Construction of Seven (07) Schools in District Qambar-Shahdadkot, Sindh

**PACKAGE NO: SBEP-P10-QSK-I**

**ADDENDUM-1**

**Minutes of Pre-Bid Meeting**

DRAWING: **SUPPLEMENTARY DETAILS FOR EMERGENCY DOOR**

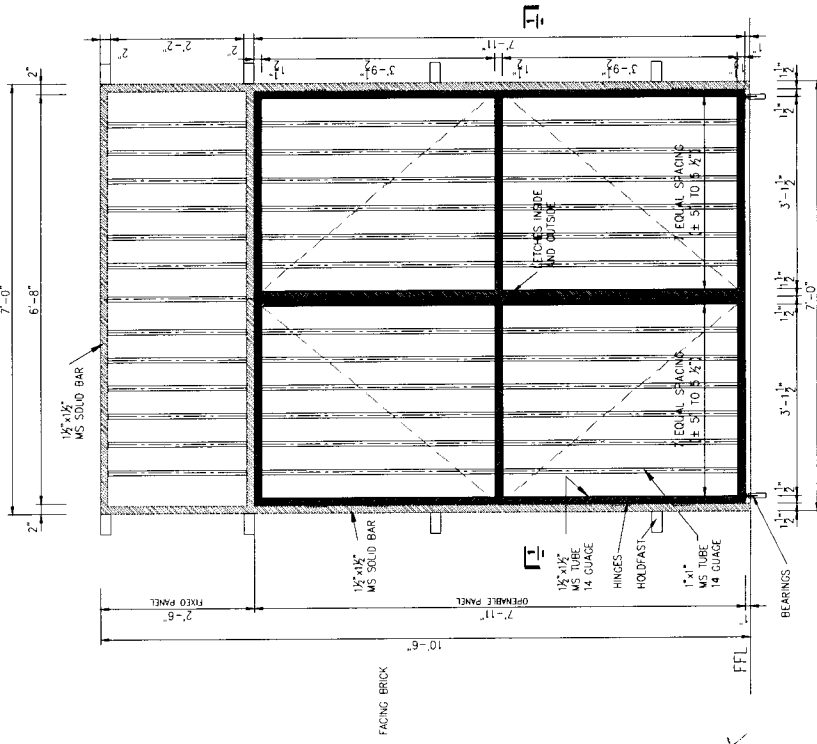
B-8	What will be ratio of RC Concrete?	Concrete mix design will be prepared as per specification, wherein ratios will be determined on lab/field tests basis accordingly.
B-9	In item # 02C 35 MS folding gate, we couldn't find the drawings of these gates. Could please provide the drawings of these gates?	Please refer Drawing No: SBEP-SUPP-AR-1022 attached herewith as Annexure-A. Also refer Section-C-13 "Miscellaneous Metal Works" in Volume-III-B (Specifications-Technical Provisions).
